Access Compliance Report

Public Rights-of-Way (Curb Ramps)

Intersection ID: N/A	Main Street: INDEPENDENCE_RD	Cross Street: N/A	Location: N
ADA ID: 2705629B056C	Ramp Type: Directional1	Initial Pass/Fail: Pass	Overall Compliance: No
Severity Score: 10.25			
Codes/Mitigation Info/Possible Solution		Field Measurements/Component Compliance

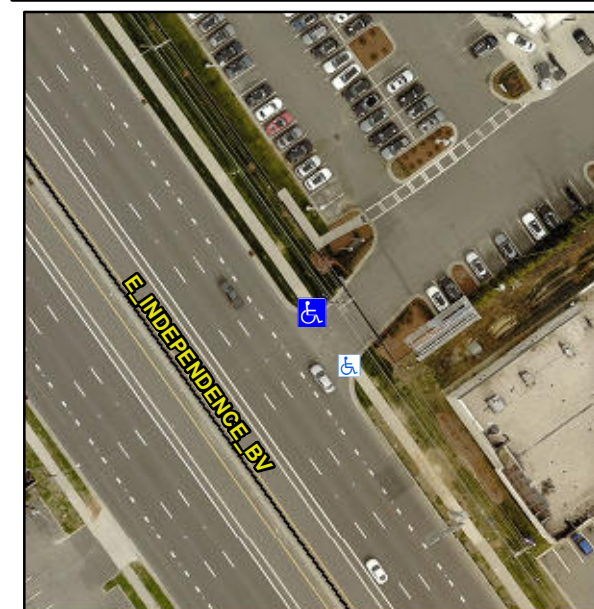
R304.5.3, R304.2.2-Perp, R304.3.2-Para, R304.5.2, R305

Compliance	Description	Data	Compliance	Description	Data
N/A	Ramp Length (in)	67.0	No	Grade Break?	No
Yes	Ramp Width (in)	72.0	N/A	Grade Break Slope (%)	2.9
Yes	Ramp Slope (%)	3.1	N/A	Grade Break XSlope (%)	2.2
No	Ramp XSlope (%)	2.3			
N/A	Flare Type LT	N/A	N/A	Flare Type RT	N/A
N/A	Flare Slope LT (%)	N/A	N/A	Flare Slope RT (%)	N/A
N/A	Flare Traversable LT?	N/A	N/A	Flare Traversable RT?	N/A
Yes	Landing Length (in)	72.0	No	DWS Provided?	No
Yes	Landing Width (in)	72.0	N/A	DWS Contrast?	No
No	Landing Slope (%)	2.3	N/A	DWS Length (in)	N/A
No	Landing X Slope (%)	2.4	N/A	DWS Full Width?	No
N/A	Landing Curb? (Y/N)	N/A	N/A	DWS Offset LT (in)	N/A
N/A	Shared Landing?	No	N/A	DWS Offset RT (in)	N/A
Yes	Gutter Ponding?	No	Yes	Gutter Slope (%)	1.3
Yes	Gutter Lip Ht (in)	0.0	Yes	Gutter X Slope (%)	1.3
N/A	Painted X Walk1?	No		Road Slope (%)	0.6
	X Walk 1 Direction	To SE		Road X Slope (%)	1.1
	X Walk 1 Width (in)	N/A		Clear Space?	Yes

X Walk 1 Slope (%)	0.6	N/A	Clear Space to XWalk (in)	N/A
	X Walk 1 X Slope (%)	1.1	Yes	Storm Grate/Utility Hazard?	No
N/A	Ramp inside XWalk1?	N/A		Storm Grate/Utility Type	
Yes	Any Obstructions?	No			N/A
	Obstruction Type		Yes	Surface Condition? (G/P)	Good
			N/A	Curb Slope (%)	9.6

Remove & Replace Entire Ramp.
